Re: Brompton Mixed Use (residential and commercial) development plan amendment – Public Consultation

# CITY OF CHARLES STURT – BOWDEN – BROMPTON MIXED USE (RESIDENTIAL AND COMMERCIAL) DEVELOPMENT PLAN AMENDMENT

## Bowden - Brompton Mixed Use (Residential and Commercial) Development Plan Amendment

## Re: Charles Sturt Council Draft Bowden – Brompton Mixed Use (Residential and Commercial) Development Plan Amendment

Subject Land Zone Boundary UC Urban Core RC Residential Character Proposed Site Development SITE CONTEXT PLAN

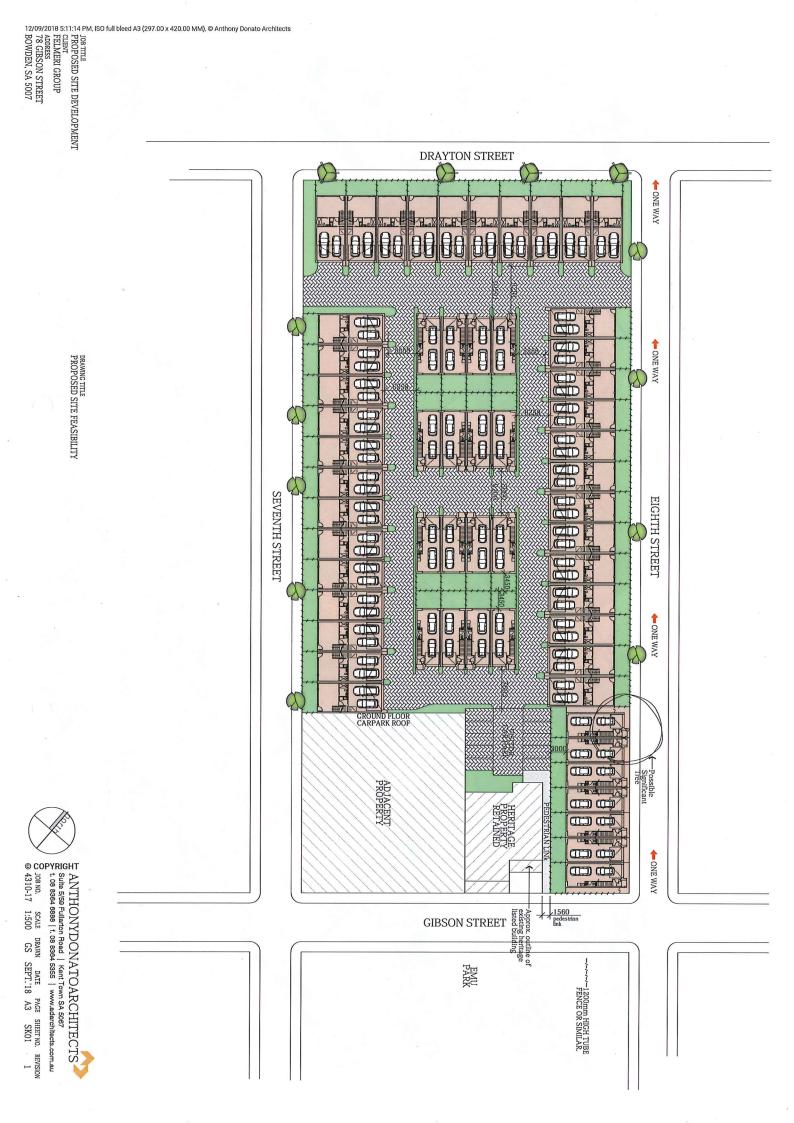
Our client has entered into a partnership with the owner of property bounded generally by Drayton Street, Seventh Street, Eighth Street and Gibson Street Bowden ("our client's site"). Our client's site is shown on the **attached** <u>Site Context Plan</u>.

Anthony Donato Architects has prepared an indicative concept for our client's site as shown on the **attached** <u>Site Feasibility</u>. The indicative concept proposes the development of three-storey residential apartments and the retention of the local Heritage Item at 78 Gibson Street. The concept is consistent with the draft DPA's Concept Plan Map ChSt/31 – Bowden-Brompton Urban Core Zone.

The conversion and adaptive reuse of 78 Gibson Street imposes constraints on the apartments proposed near the corner of Eighth Street and Gibson Street. The seven apartments shown on the Site Feasibility plan closest to Gibson Street would front directly onto Eighth Street, with vehicle access to single width garages along this section of the street. With careful attention to building design and siting we are confident that a reasonable development outcome on this part of the site can be achieved.

A mature eucalyptus tree is close to the Eighth Street boundary and it may be significant/regulated. The tree is identified on the Site Feasibility plan. The draft DPA *Investigations* at Section 2.2.5 'Existing Vegetation' advises that potentially Regulated or Significant Trees "*are generally located close to boundaries and are associated with either residential properties or small individual allotments within the area not forming part of a larger consolidated site, with the exception of the tree adjacent Eighth Street".*

Attachment 1 - Revised Concept Plan Map ChSt/31 -Bowden/Brompton Urban Core Zone plan

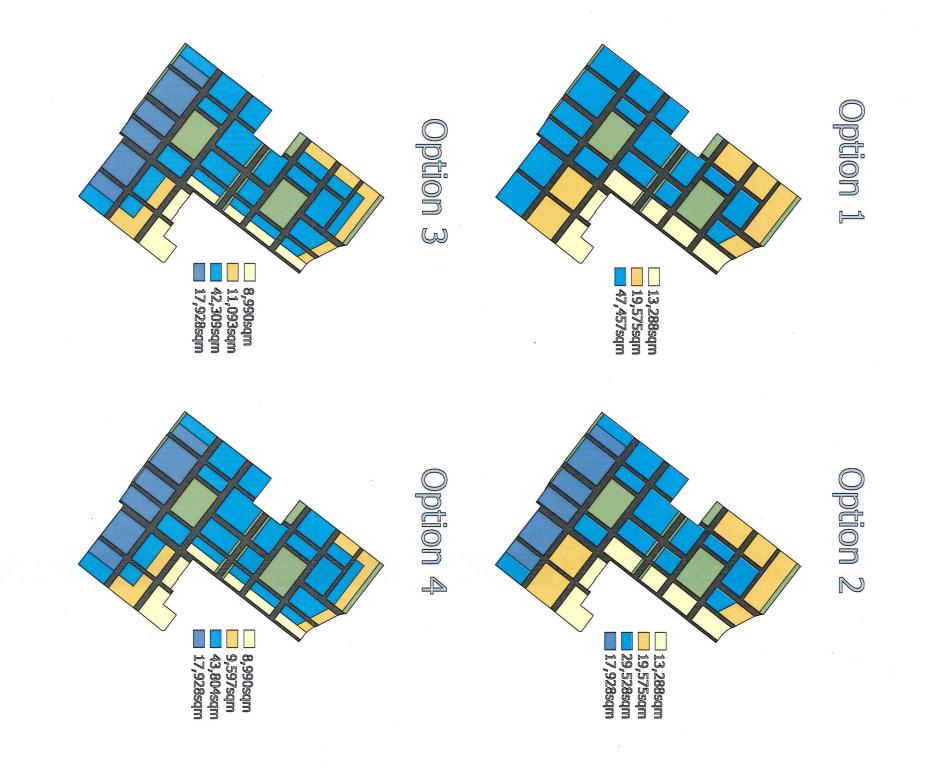
While the proposed policy framework is strongly supported and will assist in achieving a greater level of flexibility within the site, some fine tuning of the Council's *Concept Plan Map ChSt/31 – Bowden/Brompton Urban Core Zone* and proposed policy settings is considered essential.

We hold the strong view that the restrictive height limit contained in the Council's Concept Plan will not achieve the densities cited by Council nor the anticipated yield of 1500 dwellings.

Concept Plan Map Charles Sturt 31 should be revised. In particular, we enclose an alternative Concept Plan which identifies the preferred height arrangements across the rezoning area. Significantly, we do not propose to alter the height of buildings at any point along the Chief Street, Hawker Street, Drayton Street, and Gibson Street zone boundary interfaces, thereby achieving all that Council is seeking in terms of transition to adjoining areas, but do propose increasing the internal density to increase the prospect of delivering a viable development outcome.

This plan has deliberately removed open space, stormwater, road and pedestrian locations, and vehicle connections. We believe the plan needs to provide flexibility and that broad policy statements on these matters probably better facilitate a viable outcome for the area.
